Please note
Statute will require
a review of this
report at the
preliminary plan
stage.

**SOIL, GEOLOGY, AND GEOLOGIC HAZARD STUDY
THE RETREAT AT TIMBER RIDGE
VOLLMER ROAD AND ARROYA LANE
EL PASO COUNTY, COLORADO**

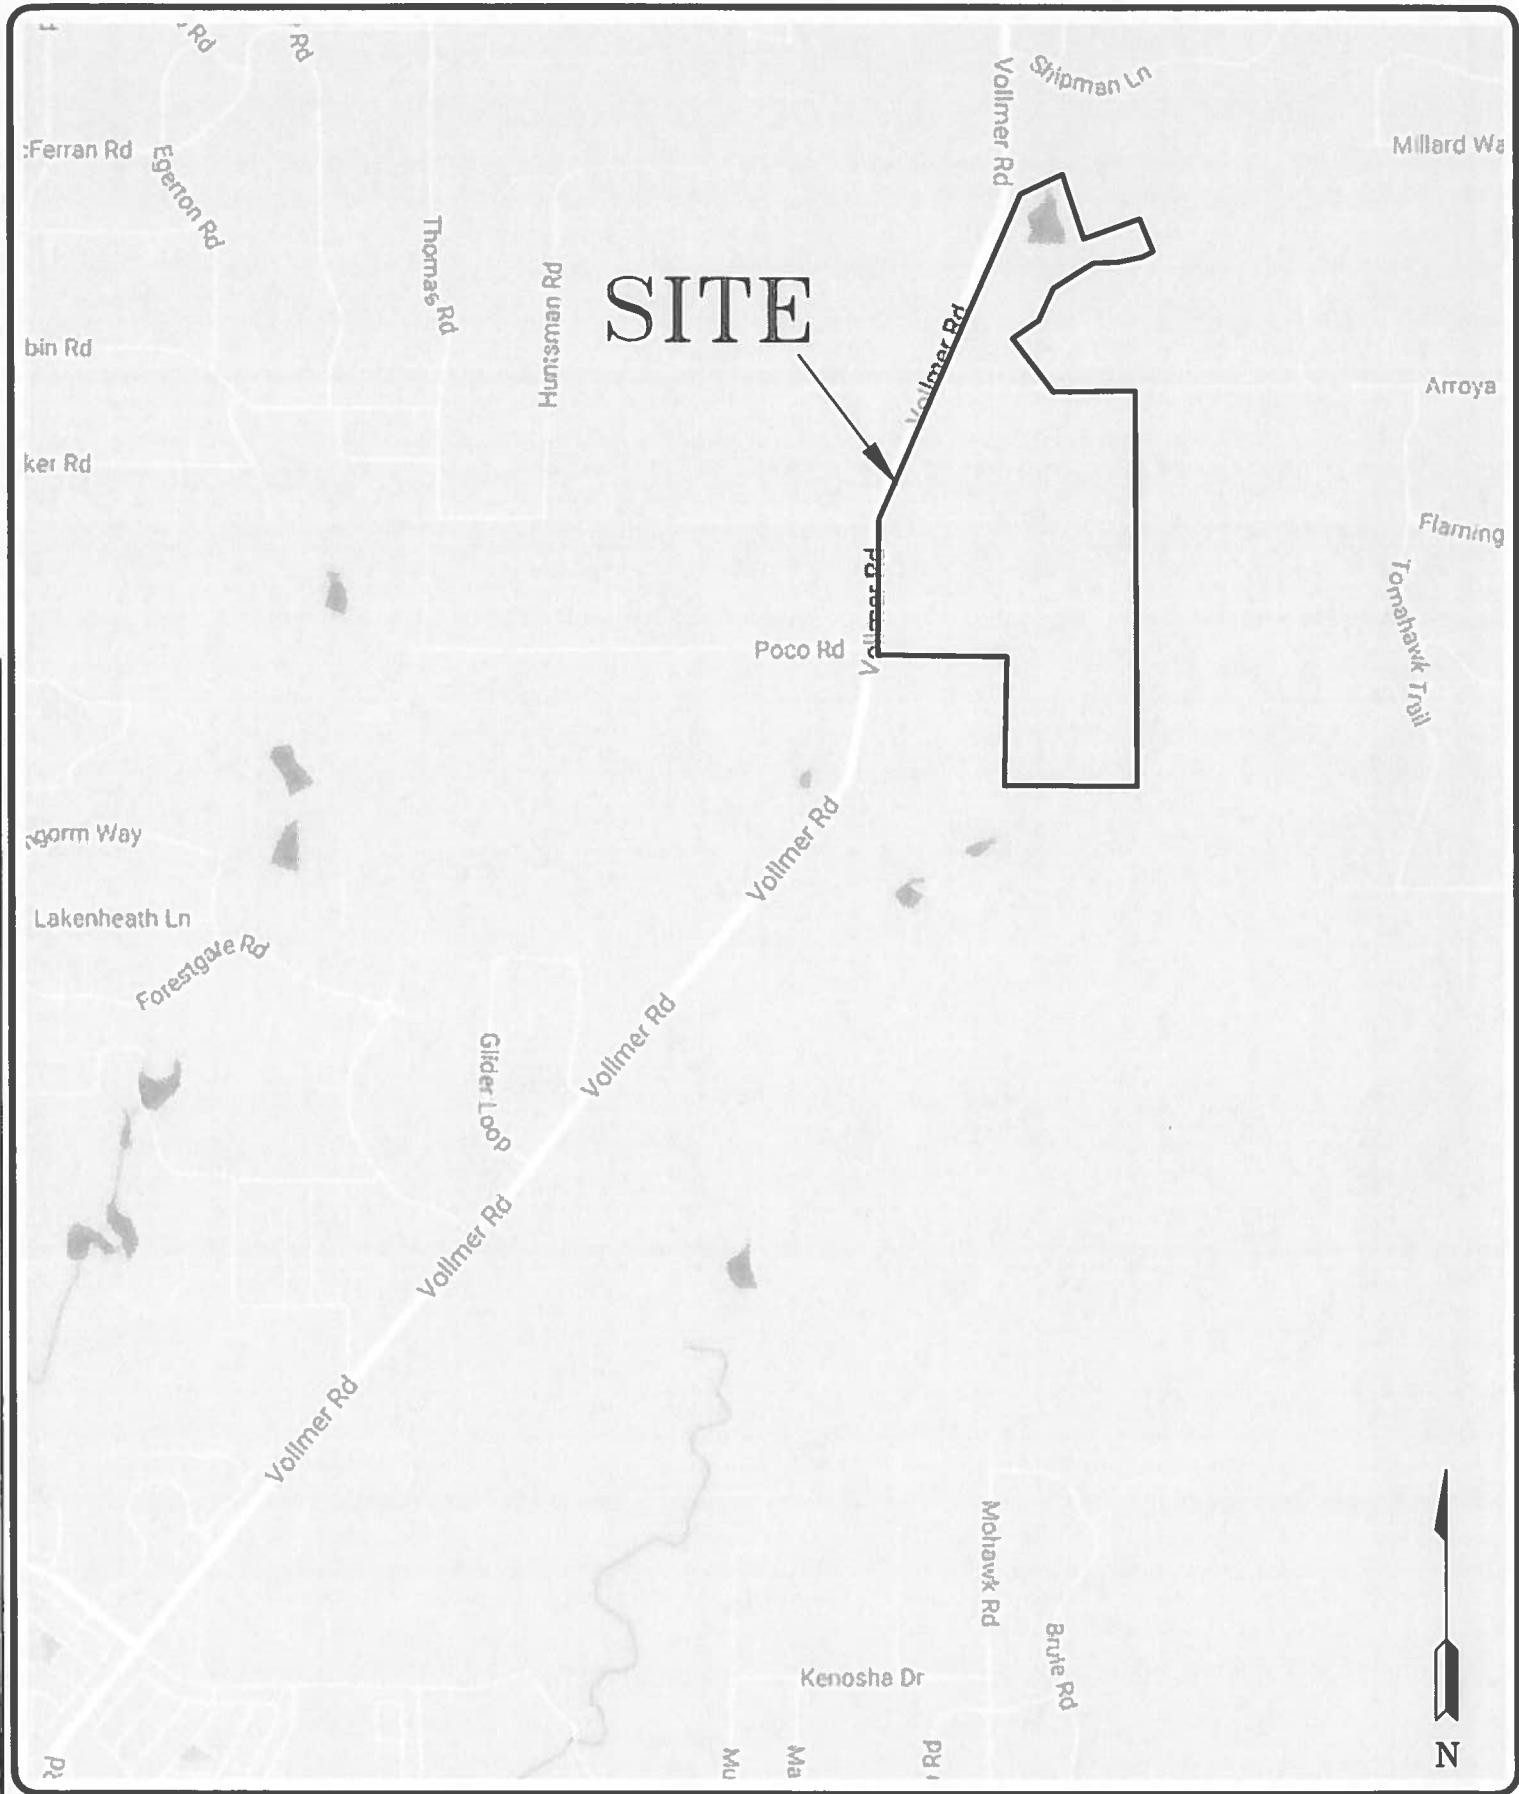
The groundwater may preclude basements on these lots. When the preliminary plan is submitted lease identify lots

PRELIMINARY CONCEPT PLAN
THE RETREAT AT TIMBER RIDGE
VOLLMER ROAD AND ARROYA LANE
EL PASO COUNTY, CO.
FOR: ARROYA INVESTMENTS

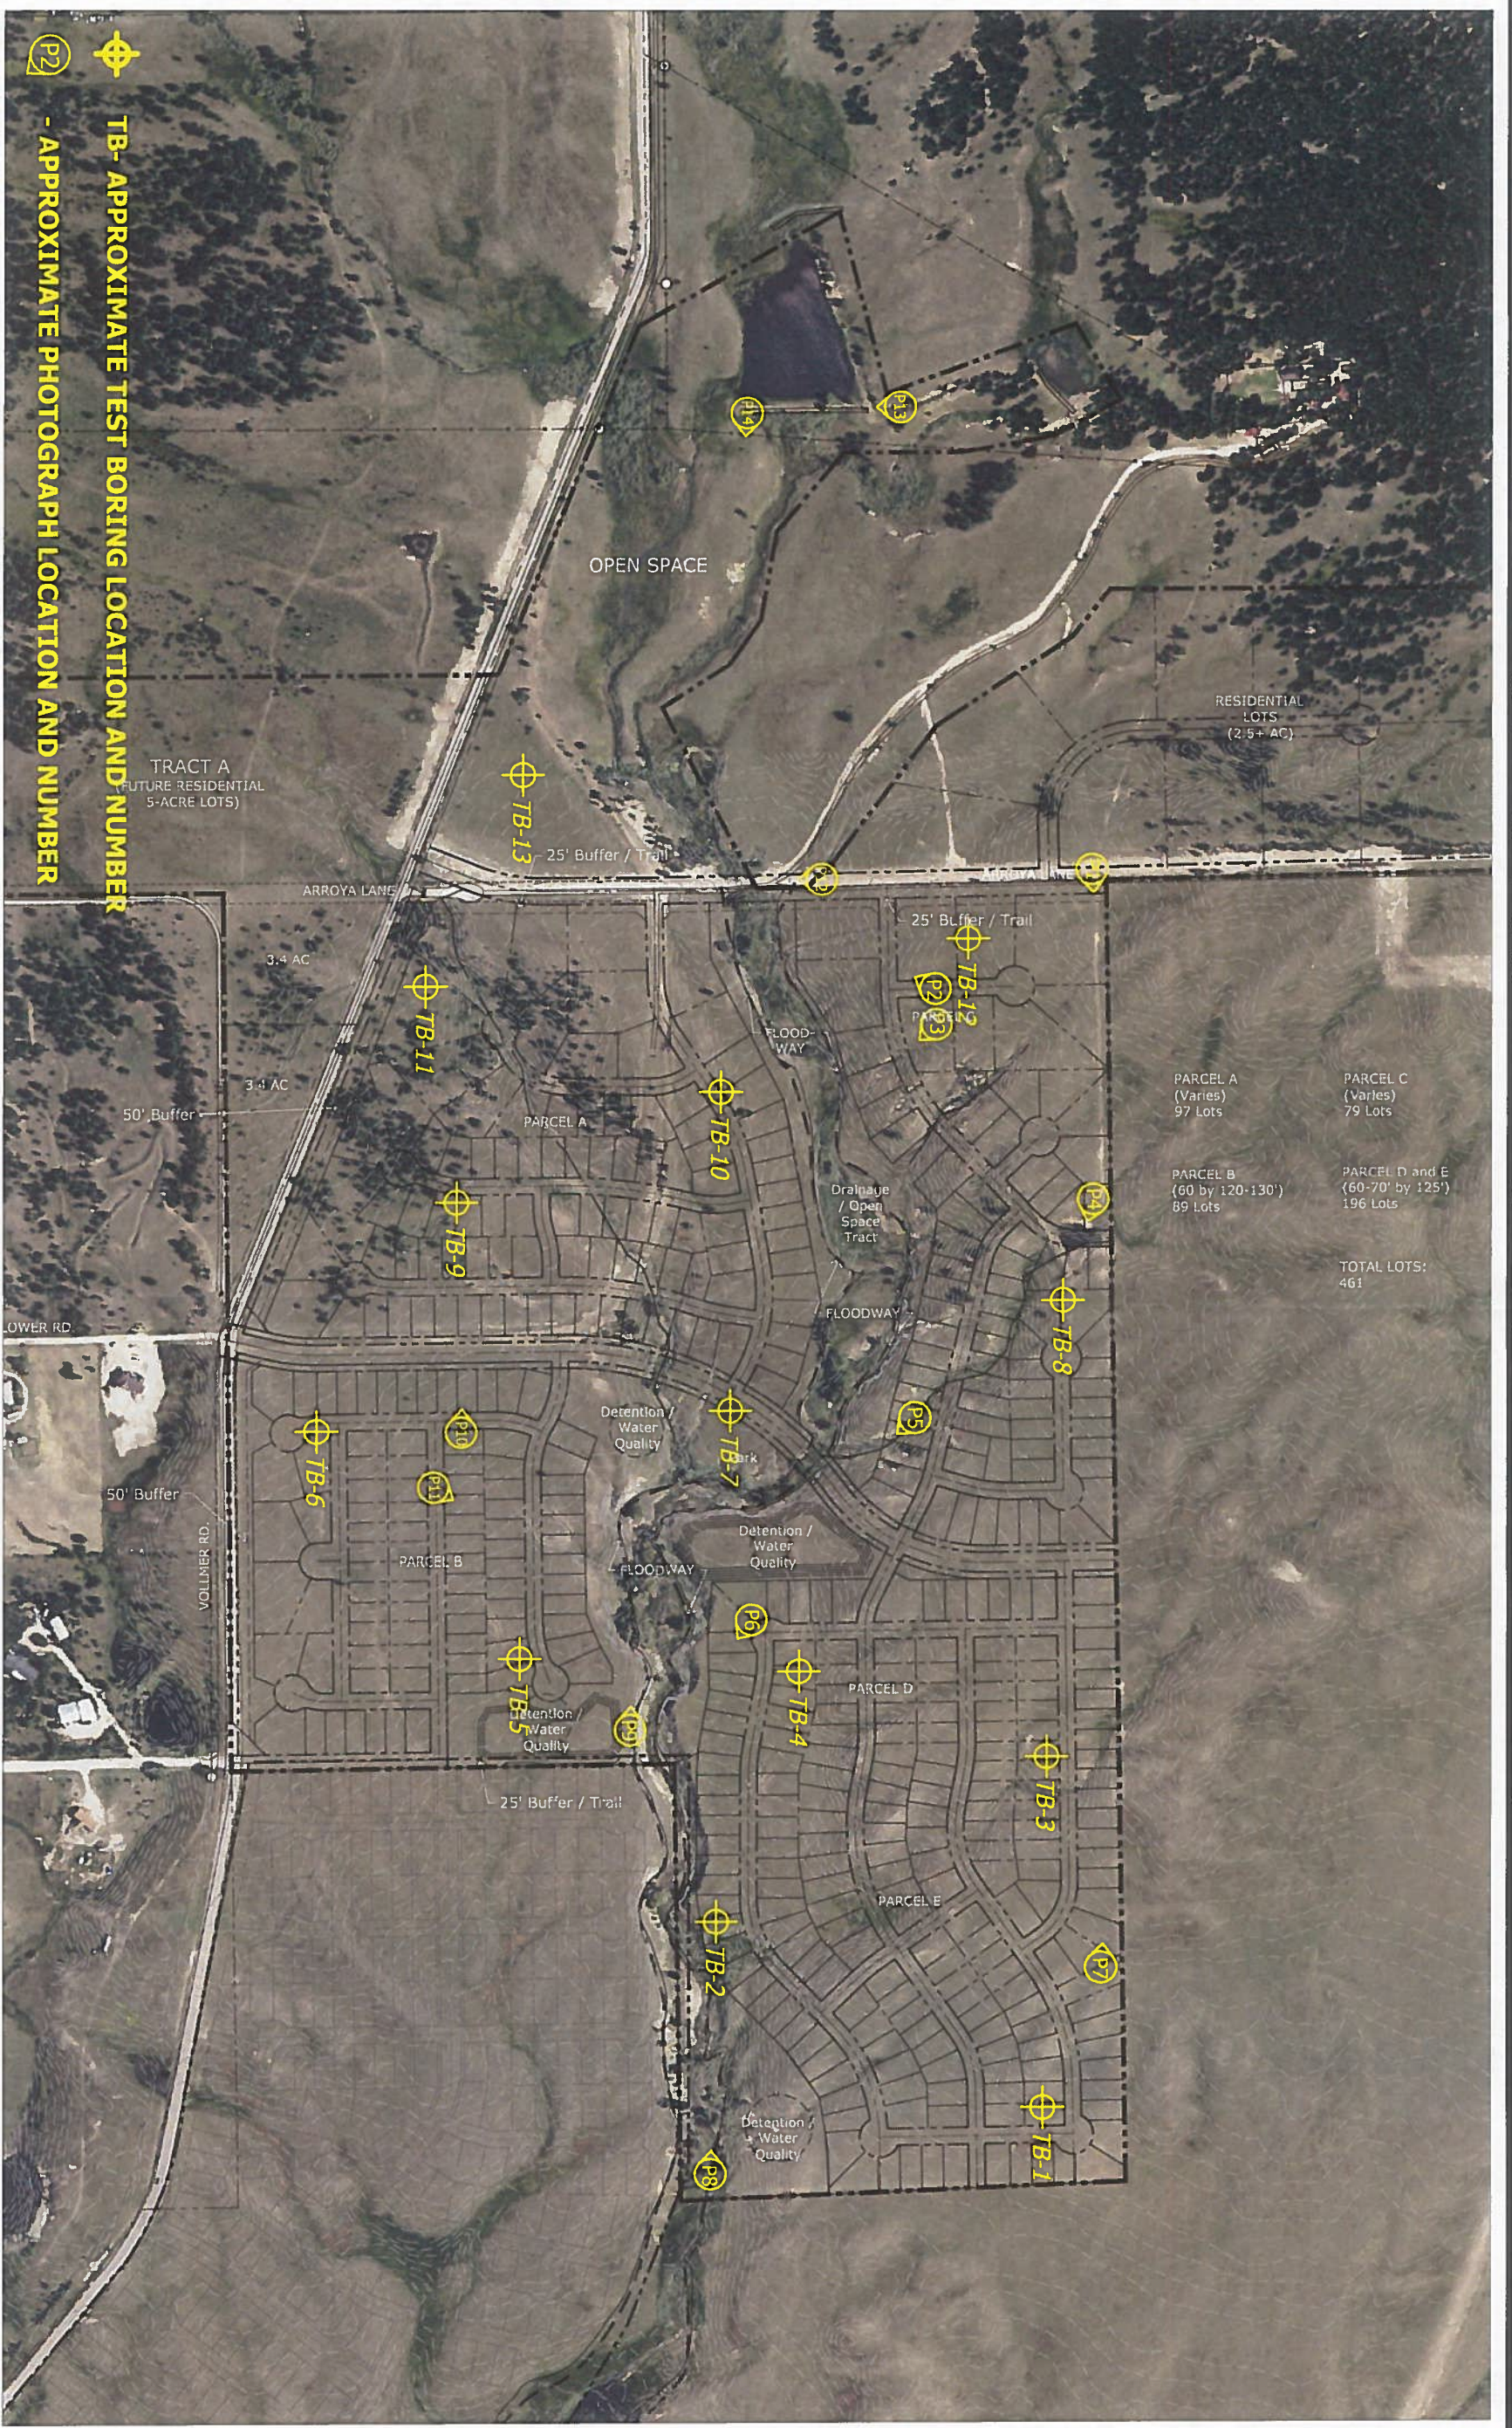
This is a PUD; we do not have a concept plan.

8

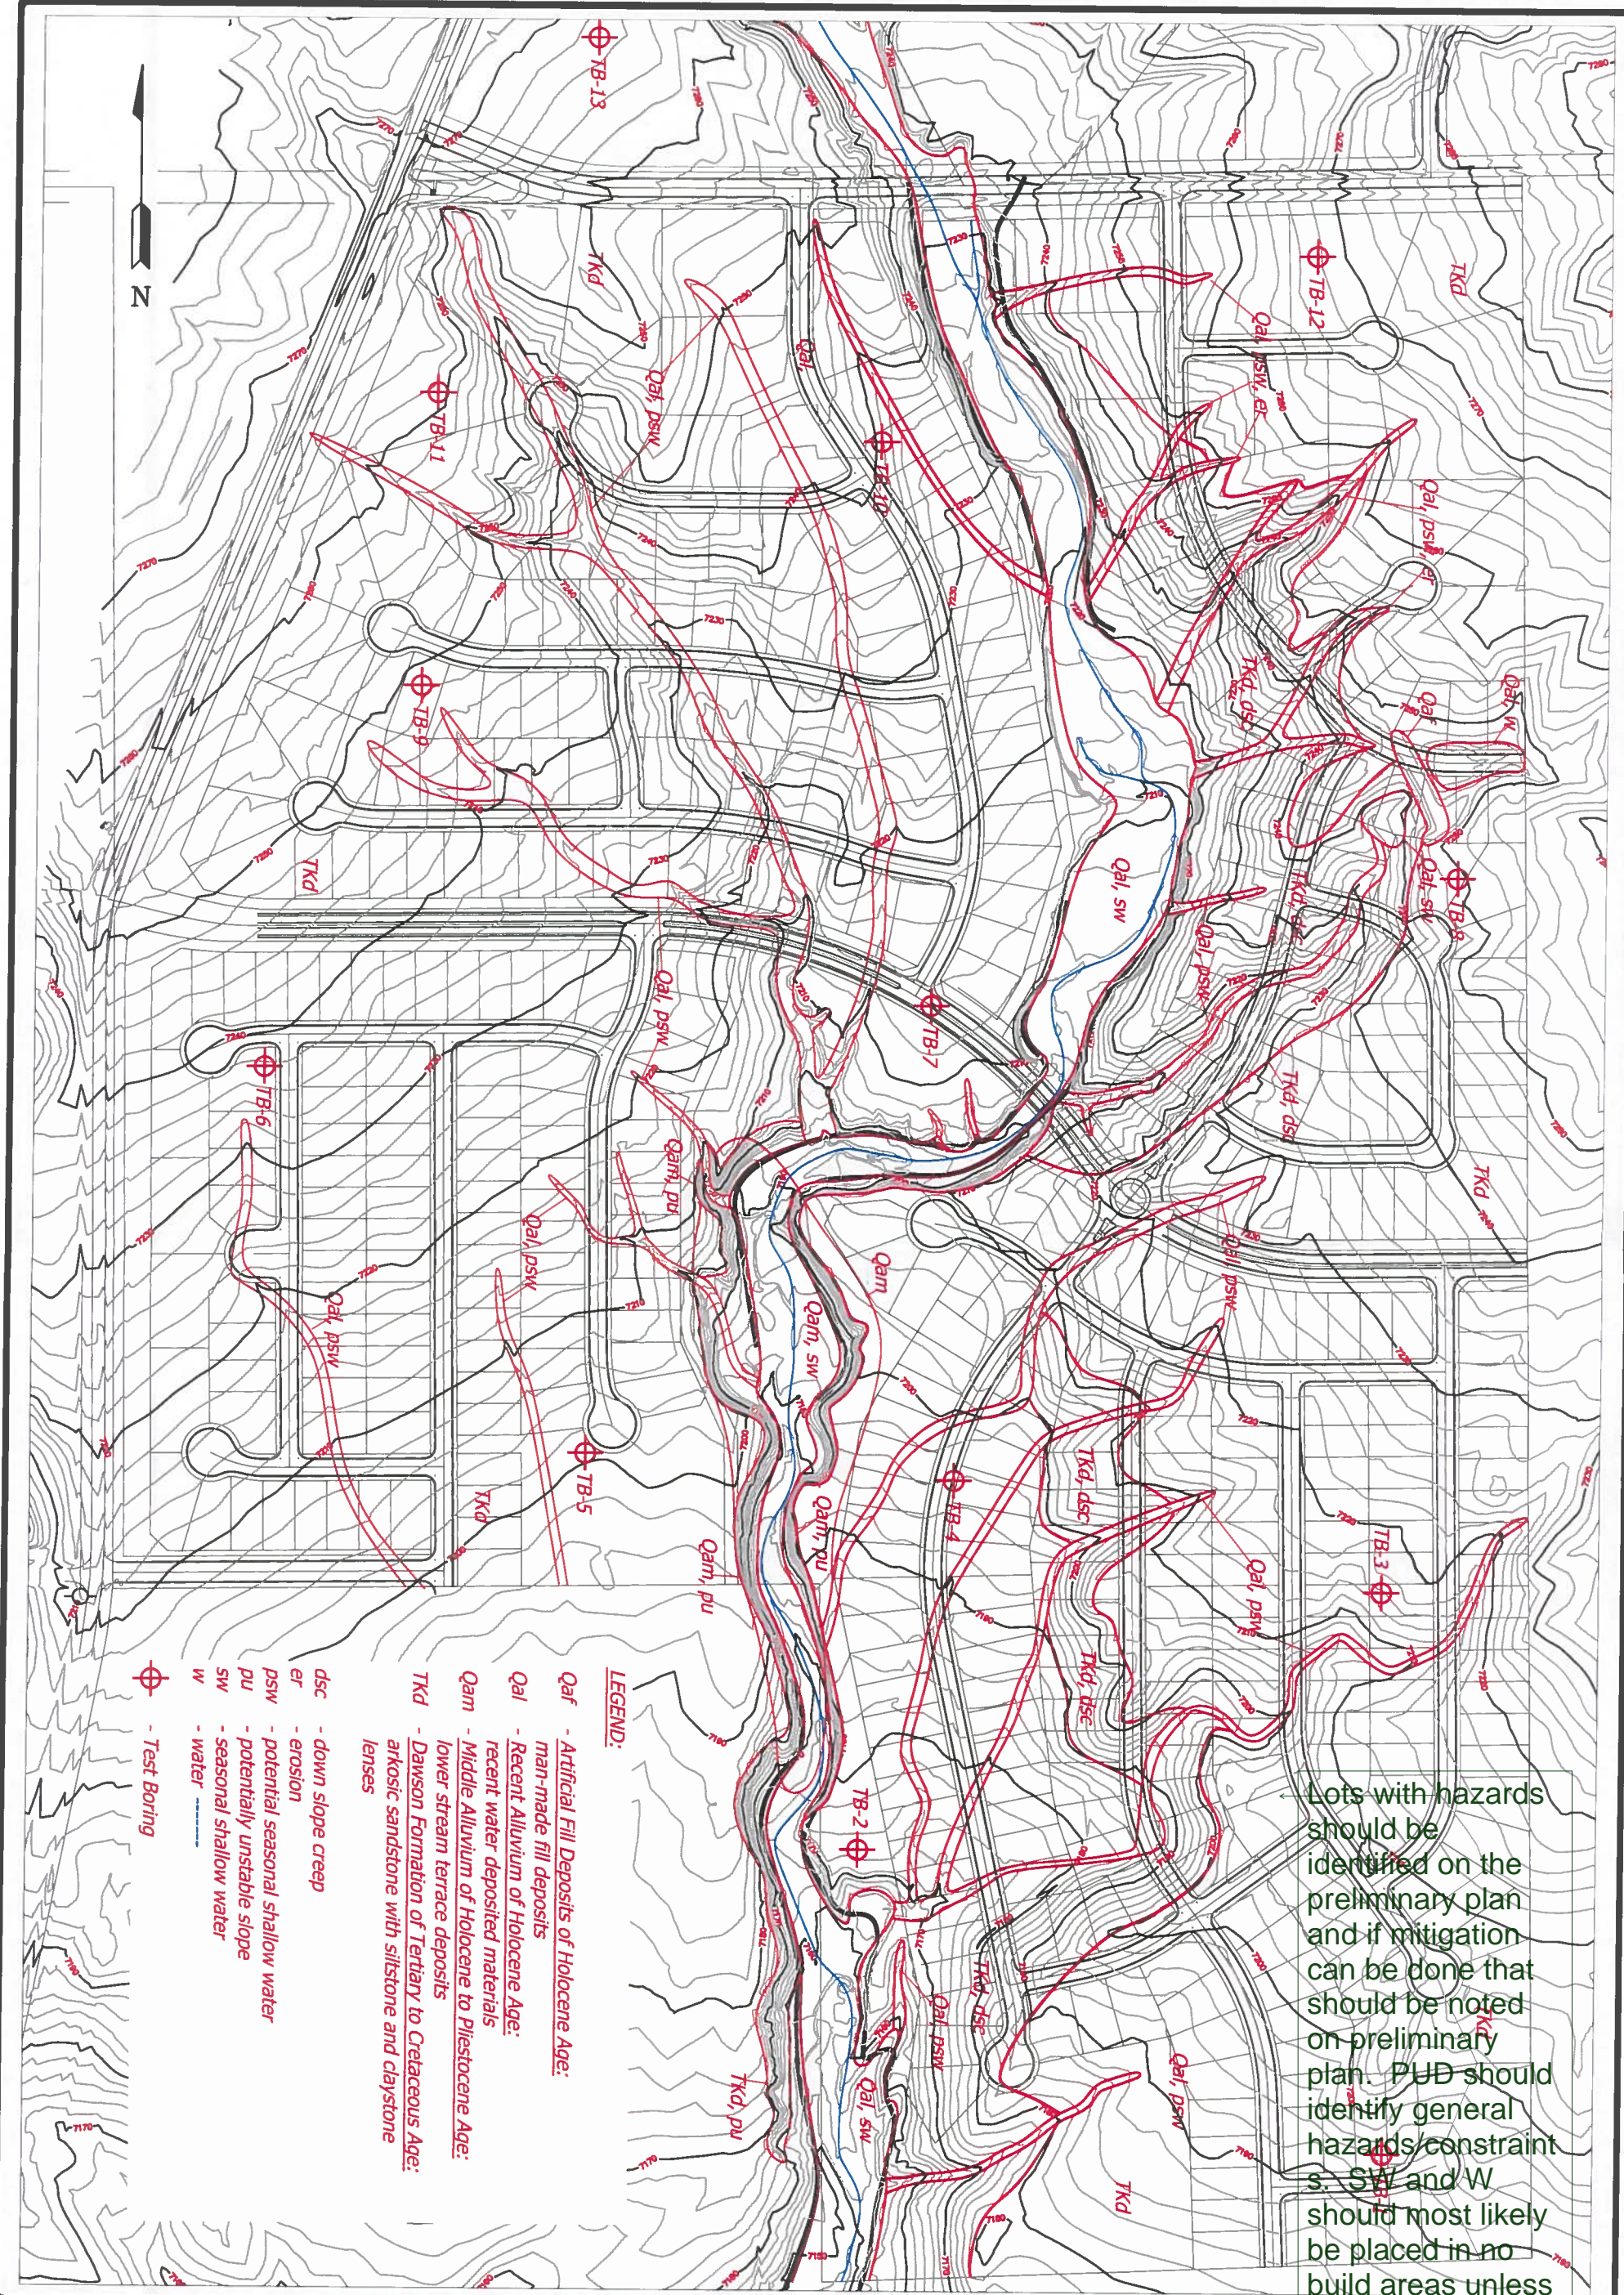
Lots with hazards should be identified on the preliminary plan and if mitigation can be done that should be noted on preliminary plan. PUD should identify general hazards/constraints. SW and W should most likely be placed in no build areas unless applicant is able to mitigate near drainage areas and sloped areas (if so note).
